Tidying up the optical specifications

Piers Dawe

Mellanox

Comparing over-emphasised waveforms

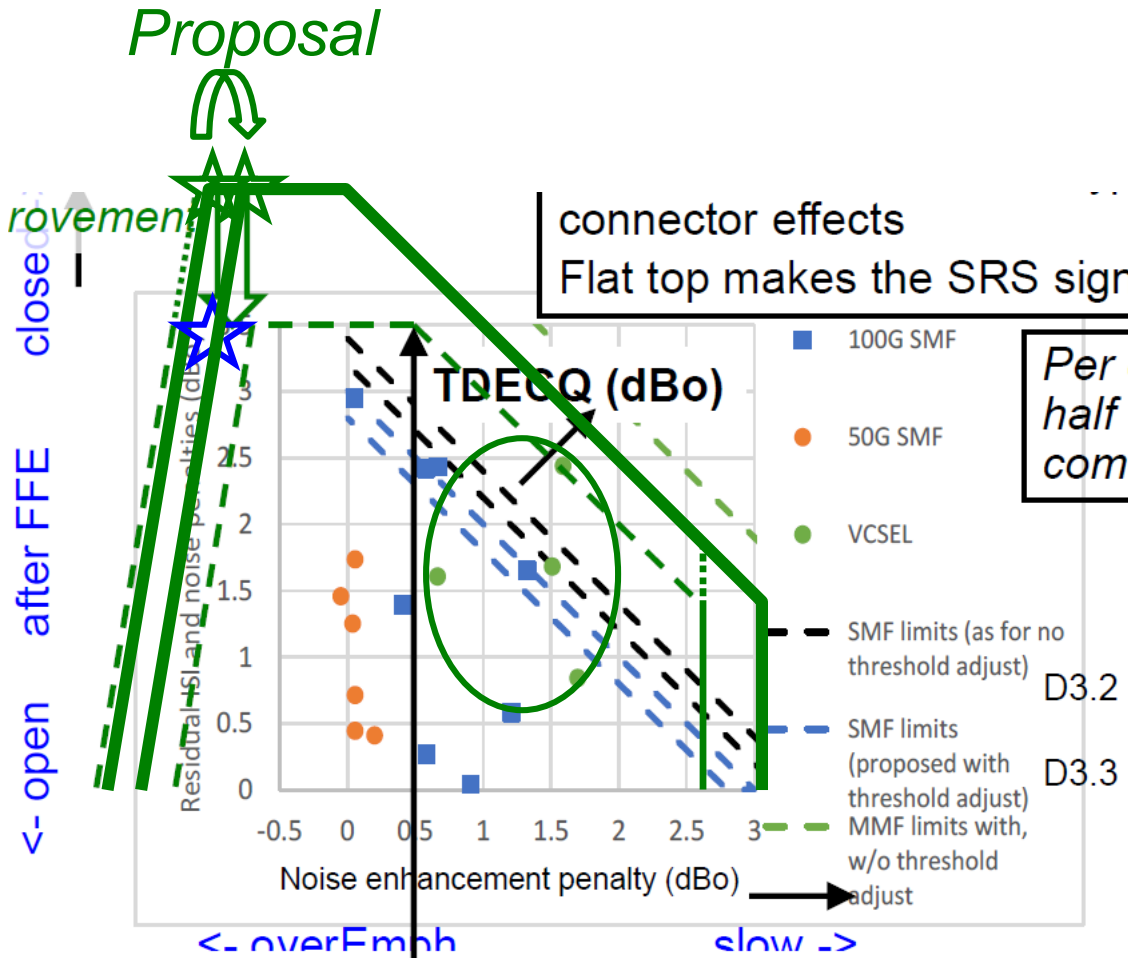
- The next slide shows simulated waveforms with the maximum emphasis allowed by the cursor minimum, and the worst TDECQ- $10\log_{10}(C_{eq})$ allowed. TDECQ is less than the limit in each case
- Left column: 100GBASE-DR per D3.4
 - Cursor = 0.8 for whichever dispersion is faster
- Middle column: 50GBASE-SR per D3.4
 - Cursor = 0.8 in 11.2 GHz
- Right column: proposed for 50GBASE-SR
 - Cursor = 0.85 in 11.2 GHz
- Real waveforms could have more overshoot than these simple ones

Actual MMF transmitters are not near this corner

- Simulations on previous page are at the three stars, top left
- Reported VCSEL transmitters are in the green ellipse, not near that corner
- From daw_3cd_01b_071 slide 19 with D3.4 limits added in **thick green**

Comment 13: make the over-emphasis rule for MMF consistent

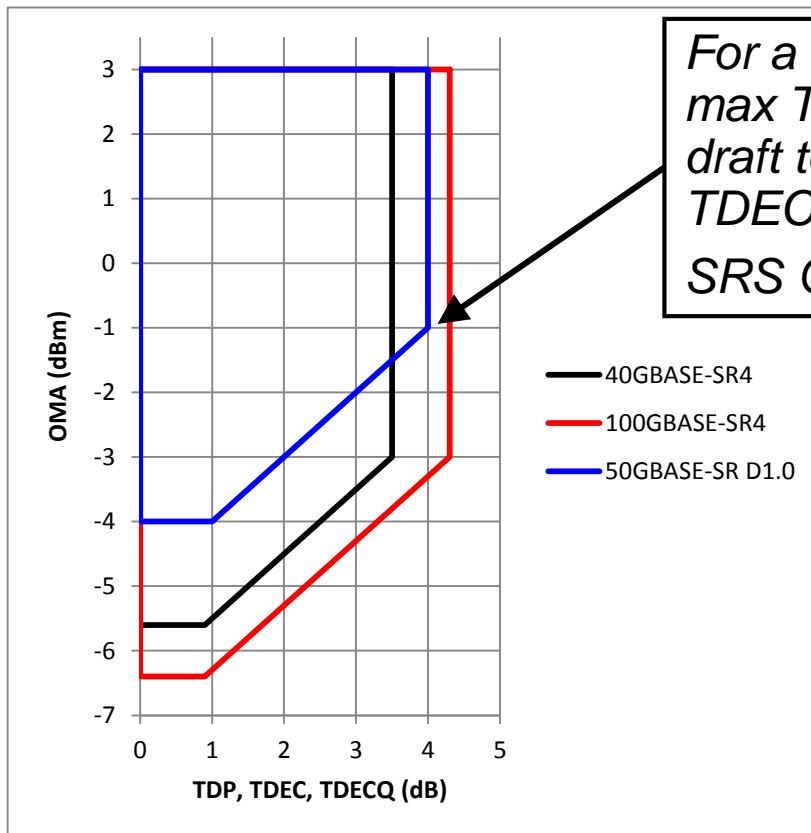
- *Cl 138 SC 138.8.5.1 P 276 L 29 # r04-13* *Comment Type TR*
- Make the MMF spec more consistent with the SMF specs so that a common equalizer IC can be used for both. While SMF TDECQ is measured for both extremes of channel, MMF TDECQ is measured for the slow channel only. That's OK, we can read across to the other case we don't measure, but recognise that a signal after a slow channel will look less emphasised than what the receiver has to tolerate. The reference equalizer's largest magnitude tap coefficient (0.8 for a fast channel) should be set consistently (as from the same transmitter) for the slow channel. *dawe_3cd_01b_0518* proposed 0.87. The survey results for MMF (green points, slide 8, *dawe_3cd_01b_0518*) are all to the right of +0.5 dB (or tap strength about 1.1). So we could tighten up more than this proposal, but this is consistent with the SMF specs and still allows a strongly over-emphasised transmitter. See presentation.

- D3.3 comment 31.
- *Suggested Remedy*
- **In "the largest magnitude tap coefficient, which is constrained to be at least 0.8", change 0.8 to 0.85.** The SMF clauses can stay with 0.8.

But the limit for the stressed receiver signal, which is calibrated for SECQ in 13.28125 GHz, should stay at 0.8: add another exception to list in 138.8.10 Stressed receiver sensitivity.

Solution - detail

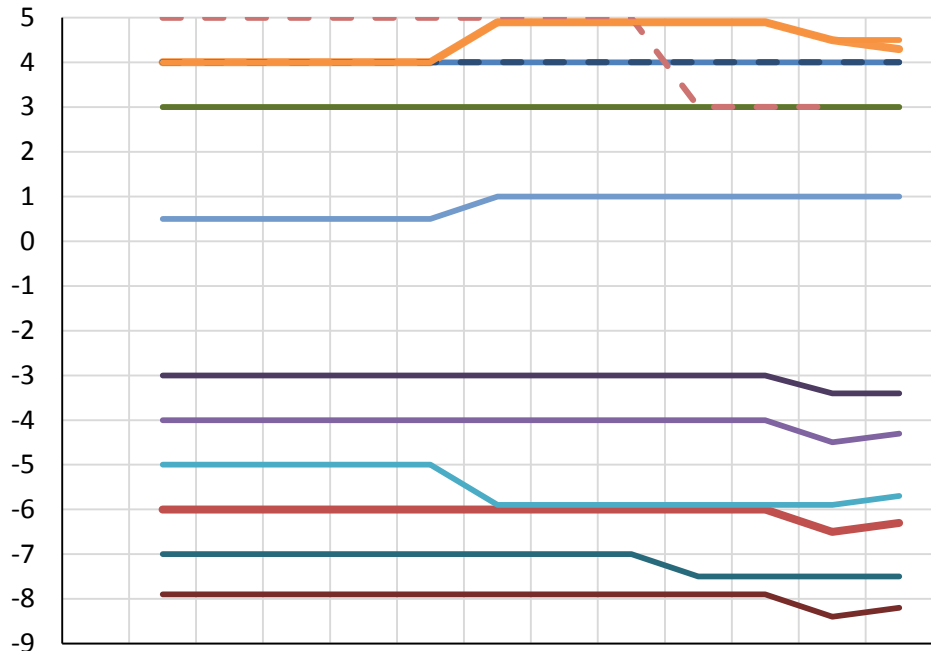
- Allocate 0.2 dB of the 0.4 dB transmitter relaxation to minor noises
 - In addition to the 0.1 dB in the budget
 - SRS and SECQ stay the same
 - Budget stays the same
 - Minor consequential changes

- Change max TDECQ and max TDECQ – $10\log_{10}(C_{eq})$ from ~~4.5~~ to 4.3 dB
- Change launch power in OMA_{outer} minus TDECQ from -5.9 to -5.7 dBm
- Either
 - Change Table 138-8, Transmit characteristics, note b: Even if the TDECQ < ~~1.4~~ 1.2 dB, the OMA (min) must exceed this value
 - Change Eq 138-1 (the other sensitivity) from max(~~-6.5~~, SECQ-7.9) to max(-6.7, SECQ-7.9)
- Or,
 - Change Outer Optical Modulation Amplitude (OMA_{outer}), each lane (min) from ~~-4.5~~ dBm to -4.3 dBm
 - with optional changes:
 - Min average power at Tx from ~~-6.5~~ dBm to -6.3 dBm
 - Min average power at Rx from ~~-8.4~~ dBm to -8.2 dBm

Building a robust link – complete proposal *

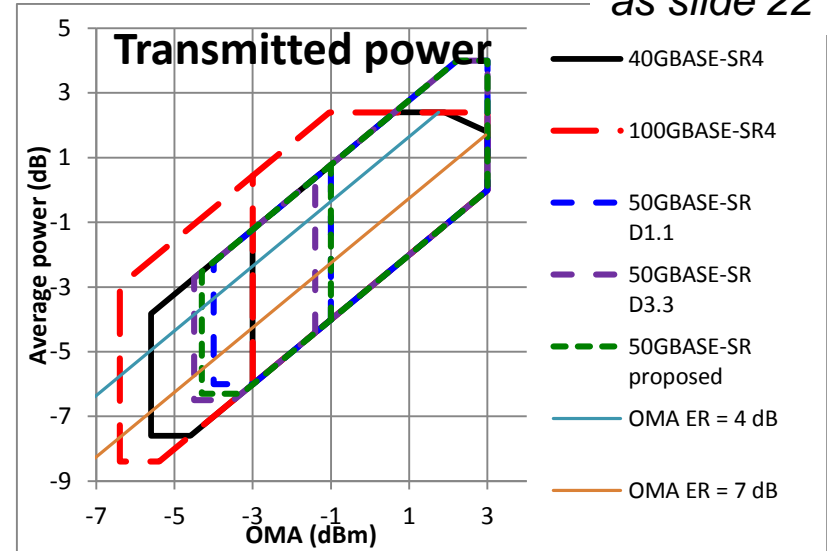
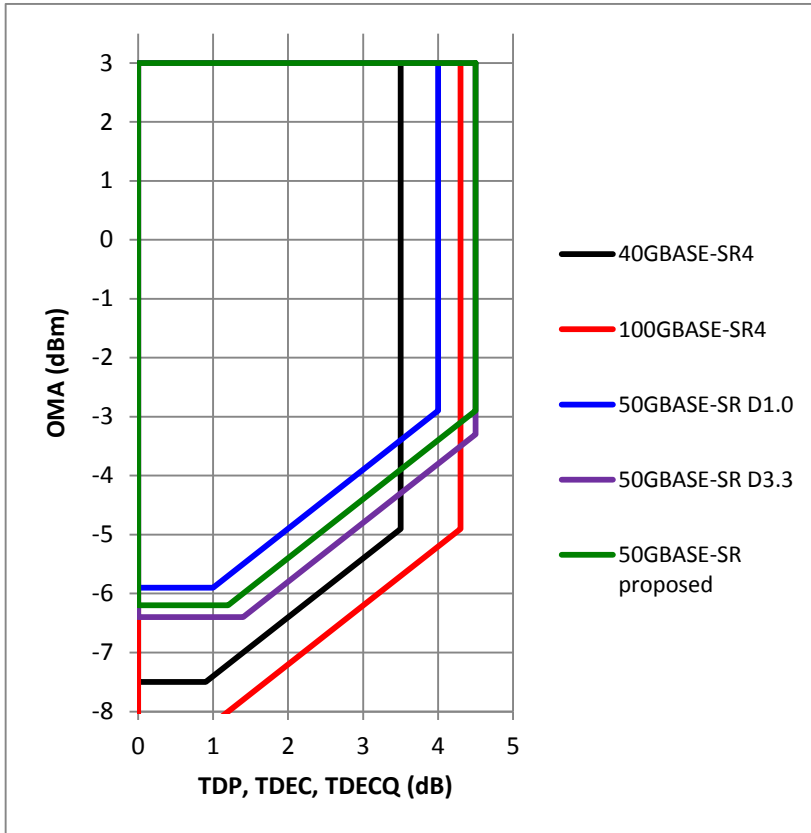
- Provides a robust link
- Allows a variety of VCSEL transmitters, leveraging the measurement improvement of threshold adjust
- Second option from previous slide
